IN THE COURT OF COMMON PLEAS OF WASHINGTON COUNTY, PENNSYLVANIA

**SITE SPECIFIC ADVISORY BOARD under the
auspices of the Nuclear Regulatory Commission
RESPONSE TO COMPANY JUNE 8, 2000
PRESENTATION for The Decommissioning Plan
Washington, Pennsylvania.**

Restricted area section of the Plan

Figure 2-7 Active Plant Site and South Property with Locations of Elevated C. Radiation Levels, 1985

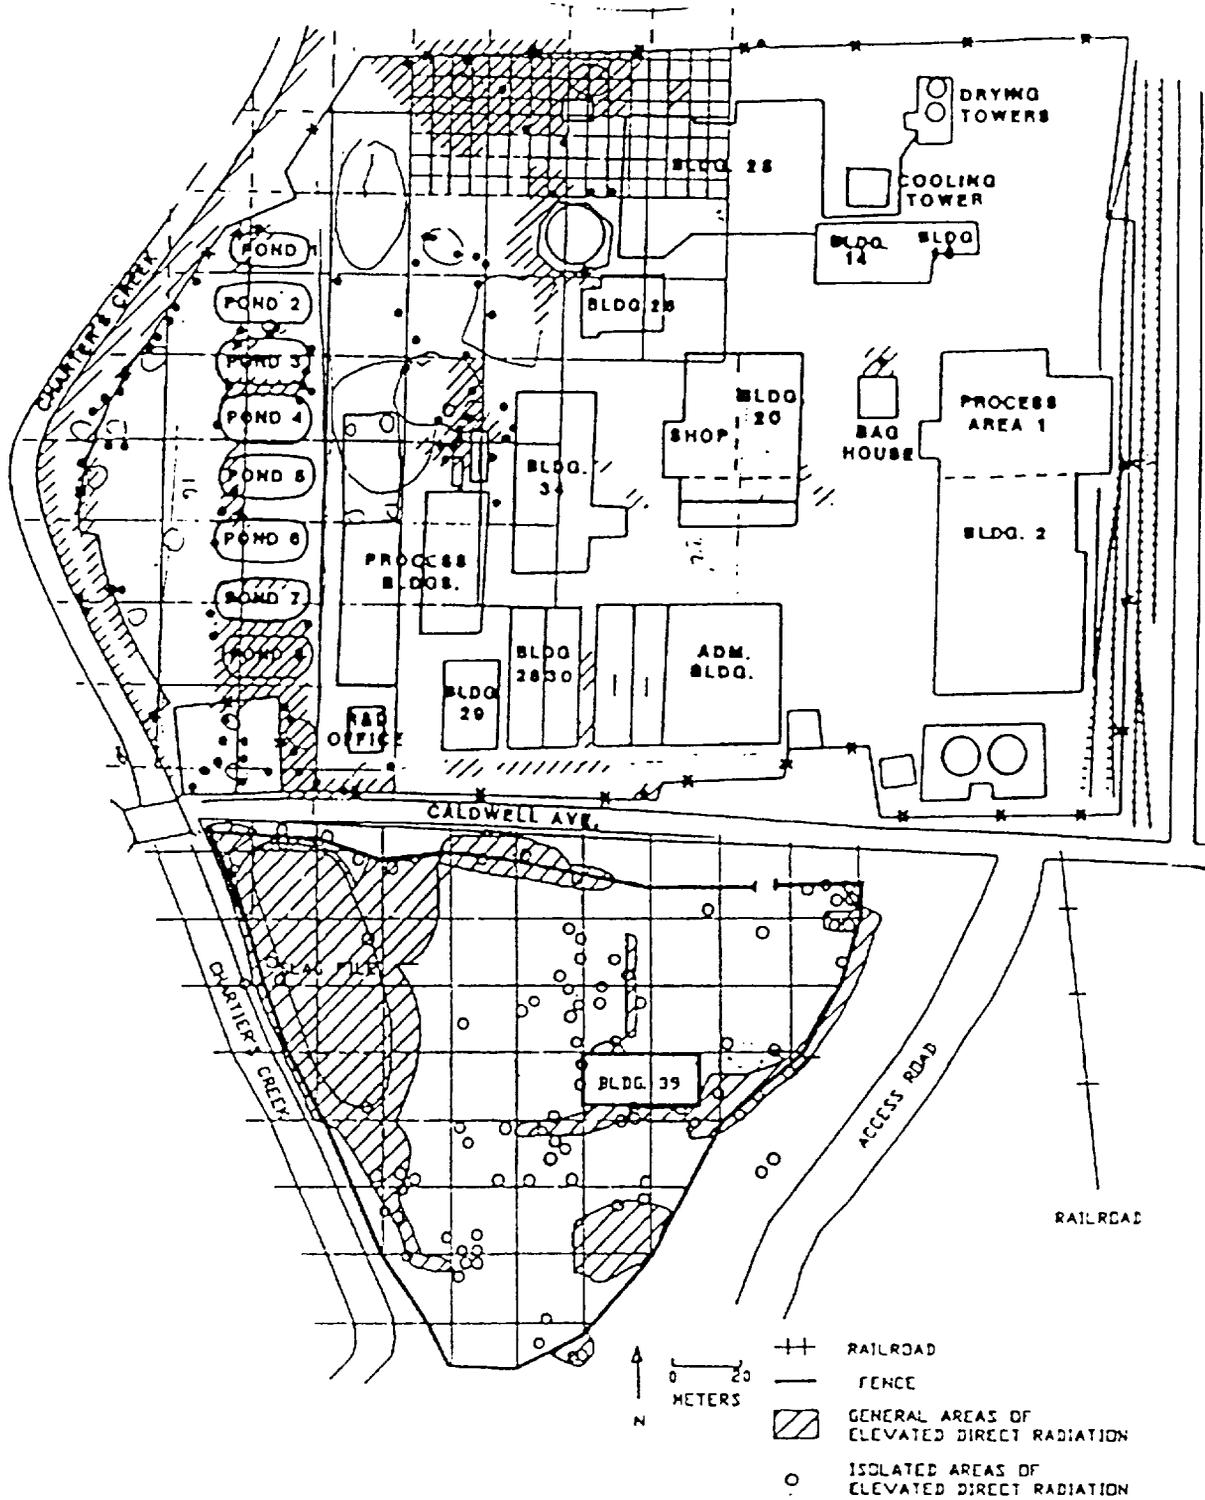
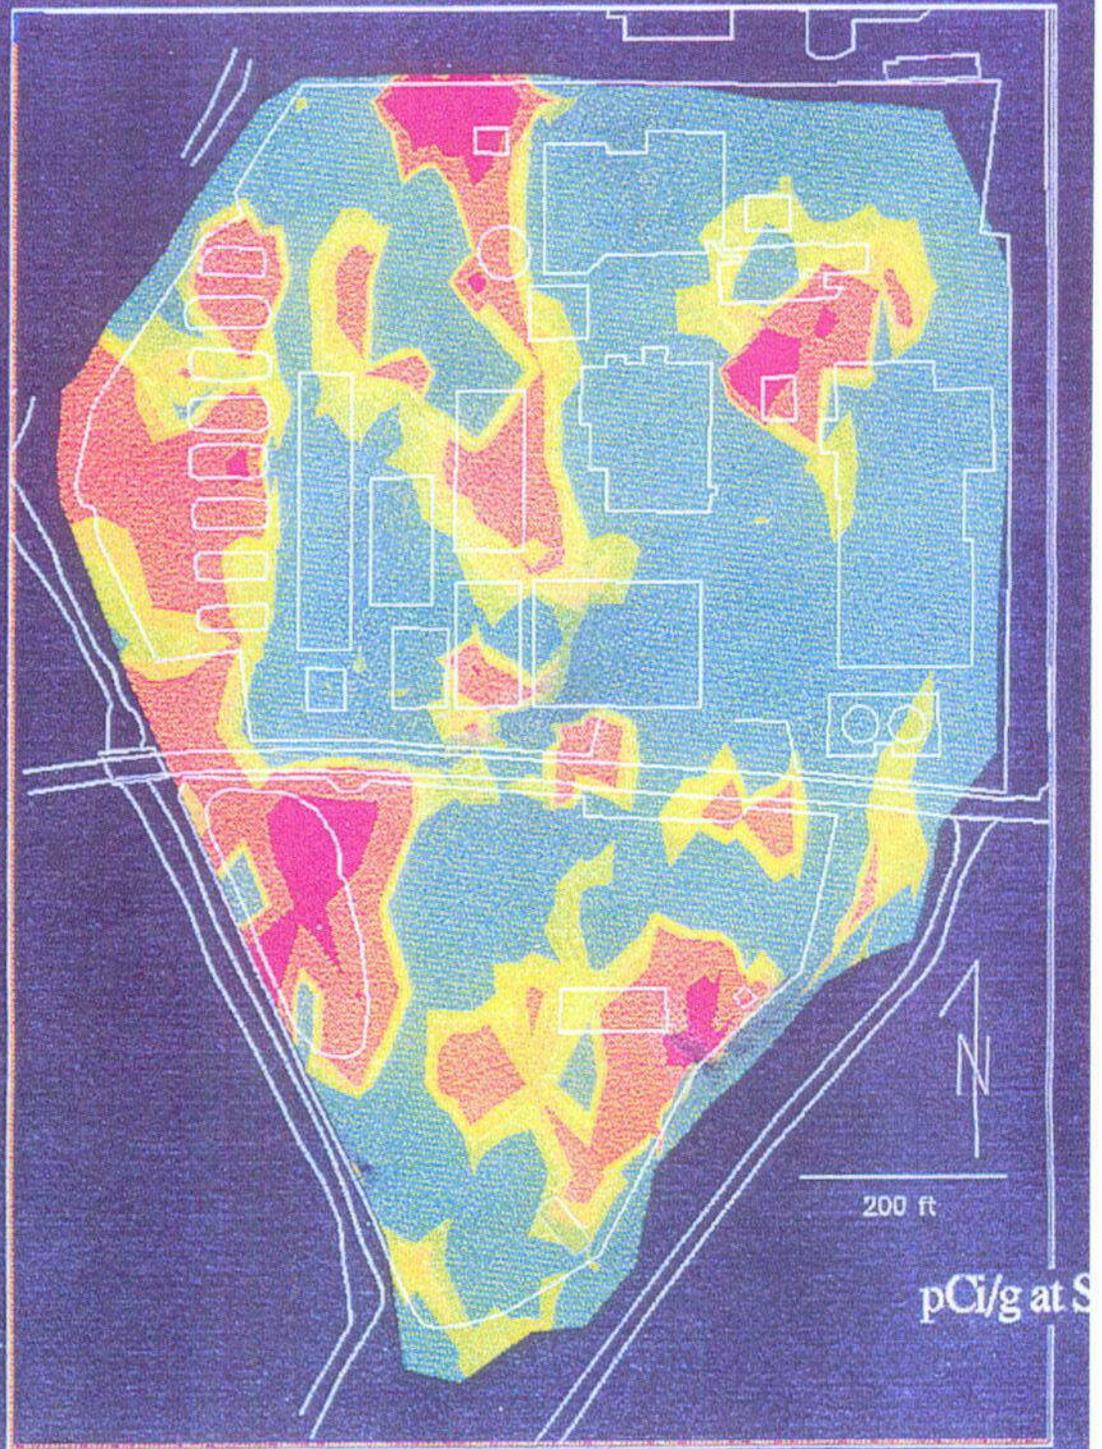
Figure 5 -- 7 section 5 portrays concentrations in the pCi/g's at the surface level and is included as an exhibit. (reader we have included figure 2-7 as a ready location reference). The heavier concentrations in Fig. 5-7 the northern border with Findlay Clay and in the approximate area of the current mound on the south property and in the southeastern section near RT I-70 and building 39 and near

FIGURE 5-8

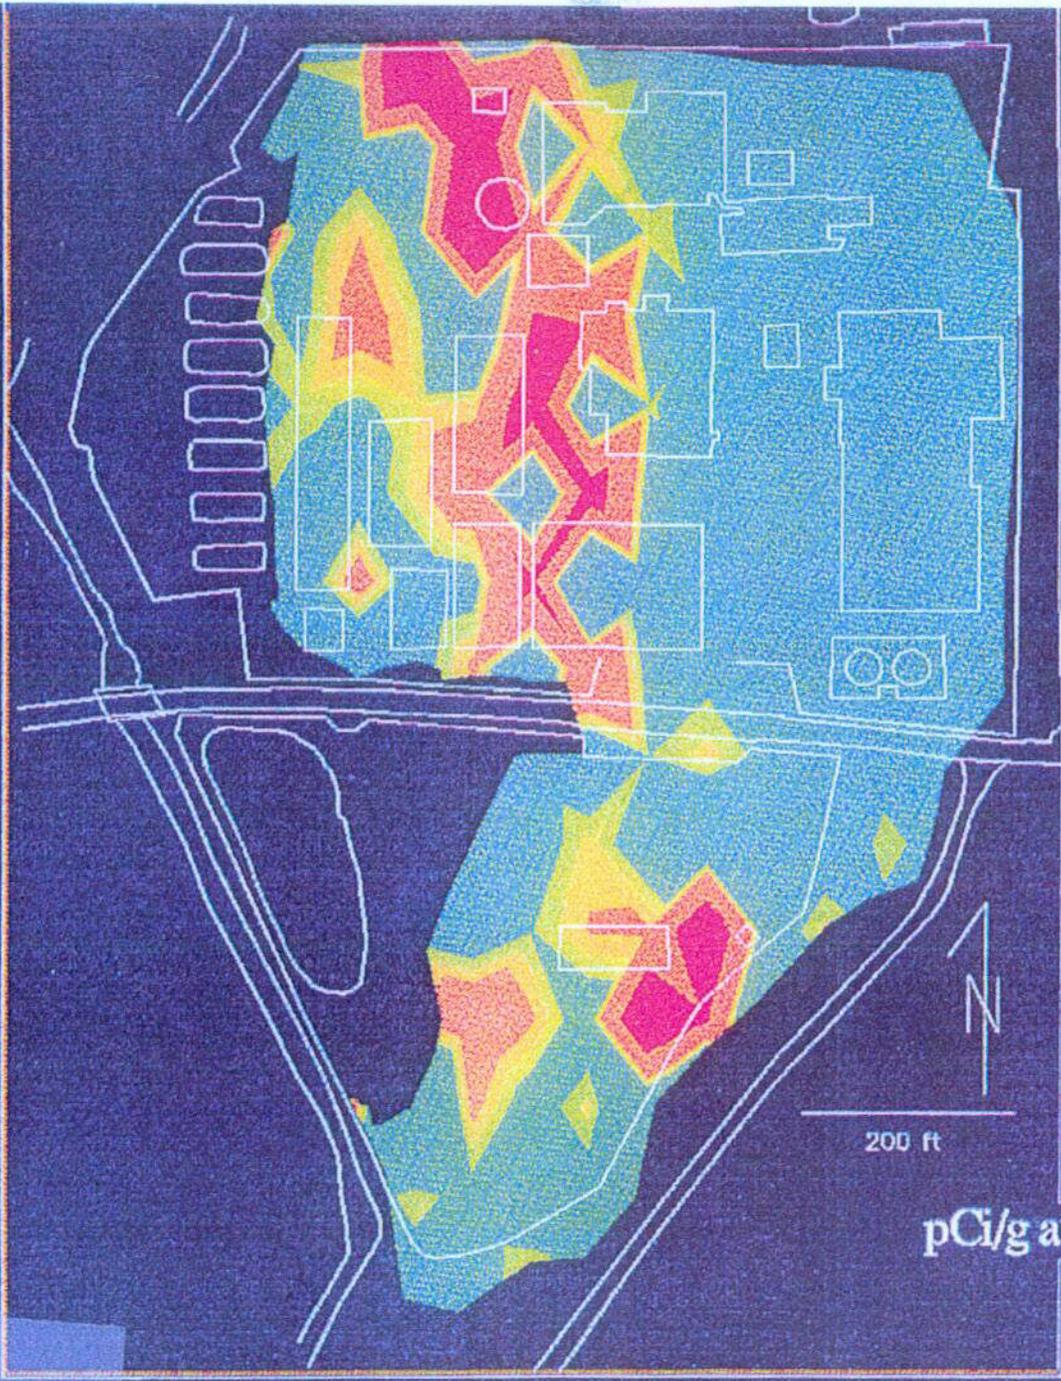
the bag house in Northeastern section of the plant site. There are also substantial sections between 10-15pCi/G in these same areas as mentioned above but broader in coverage area. The heaviest concentrations are figure 5-8 at a depth of 1034 feet shows an area of concentration near the bag house. In Fig 5-10 at 1026 feet concentrations are primarily located within areas of the manufacturing facility near building 26 and the south area of the plant across Caldwell Avenue near building 39 extending from there in a strip across Caldwell Avenue and including Caldwell Avenue. If we are interpreting this correctly there is alleged off site contamination under Caldwell Avenue. The southwest corner and figure 5 -- 11 concentrations at 1,022 feet include capabilities within the center of the plant area (at or near bldg.'s. 29, 28, 30, process buildings, shop and extending Northwest to the border with Findlay Clay), as well as strong concentrations in the southeastern corner of the south side in a wedge shape. The 1018 feet figure 5 -- 12 concentrations 50 pCi per gram are included in the leaching ponds of which there were 8 on the manufacturing facility. The company claims during a walking tour of the proposed cell site that the 8 ponds have been cleaned up and filled with clean fill material. There is no substantiating basis of independent fact regarding this statement. Only this verbal statement. If interpreted correctly one could allege that part of this extends to Chartiers Creek. If interpreted correctly there is off-site contamination in Caldwell Avenue this extends from the plant site across Caldwell Avenue to the mound along the south and southwest side of property along Chartiers Creek. This south property area is where Canton Township alleges that the 16 Inch, Pennsylvania American Water Company line is located. This is the old main water line from the processing plant in North Franklin that was fed by dams 1-4, It correlates with the location of the former leaching ponds. This information leads one to allege that the large south property leaching pond was directly over the water line for an extended period. This pond contained over the years hundreds of thousands of gallons of thorium and perhaps uranium effluent that leached and evaporated. It is the material, that when the water evaporated, was bulldozed into the current mound. There is a very large area that allegedly have been one of the leaching ponds on the southern portion of property. It extends from about Building 39 northwest, west and southwest to the border with Chartiers Creek. I had one man tell me that he went swimming in this leaching pond. There is a smaller area to the south of building 39 at 5-pCi/g this broadens out into an area of 15pCi/G larger in area including building 39 and to its north. If one examines the figure 5-12 it could be alleged that it extends to Chartiers Creek in the southwestern corner. Within figure 5-12 there is a large area on the plant site near to and including building 36 and a round pond like area. There is one small area near Chartiers Creek outside of the 8 old ponds on the main plant site at 50pCi/G right near the border with the creek. Figure 5 - 13 at 1016 feet shows heavy concentrations in the area of the south section of the property directly where the alleged Pennsylvania American Water Company waterline is located from the standpoint of Canton Township. This corresponds with figure 5-12. The area extends from Caldwell Avenue into the mound to the south extending in a curve to building 39. There is another large area to the east

FIGURE 5-13

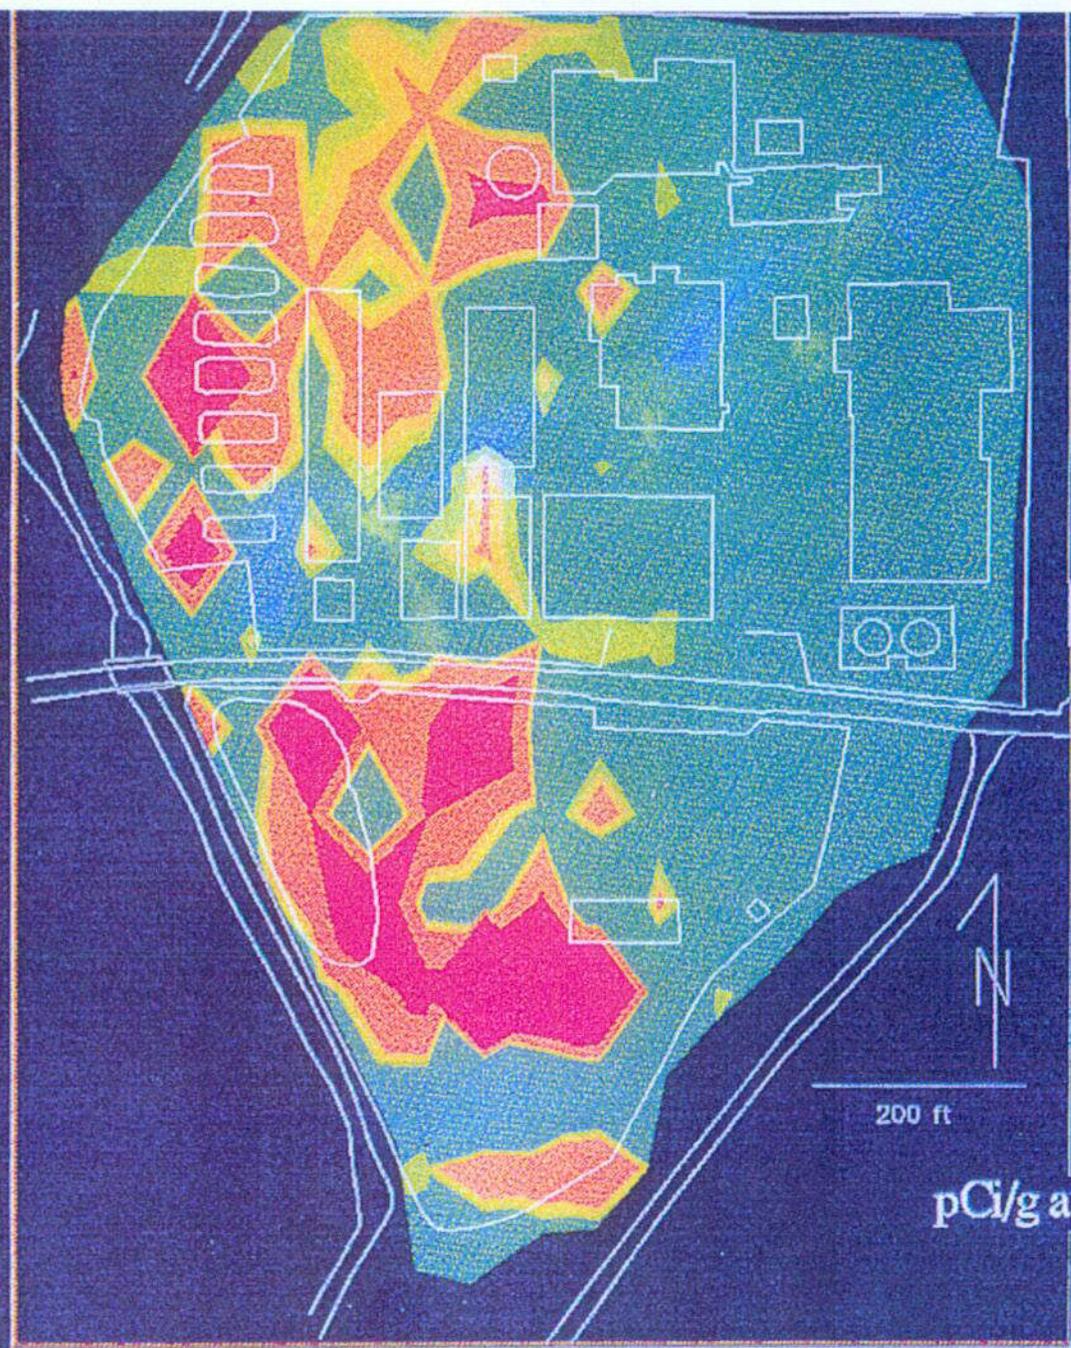
On page 5 - 25 volume 1, states the majority of the elevated thorium concentration is evident in the shallow areas both North and south of Caldwell Avenue. Figure 5 -- 13, at the 1016 level, indicates the highest concentrations, greater than 50 pCi per gram, rapidly decreasing the northern sector within two feet. Figures 5 - 10, 5-11, 5-12, 5-13,5-14, In 5-14 show areas of contamination that allegedly cross Caldwell Avenue, at the mound on the south portion of the site is a large area of contamination in the center of the south section and in the south center area of on the southern most portion. On the plant site there are areas near the former ponds and on the north boundary with Findlay Clay. In 5-15 there are area of contamination on the south parcel to the east of the mound and on the plant site near to the border with Findlay Clay. On Figure 5-16 there are areas of contamination in the center of the south parcel and plant site near the former ponds and an area from the north west corner in 3 areas extending to under building 25 on the border area with Findlay Clay. corresponding to 1014 feet, 1010 feet and 1006 feet above sea level.
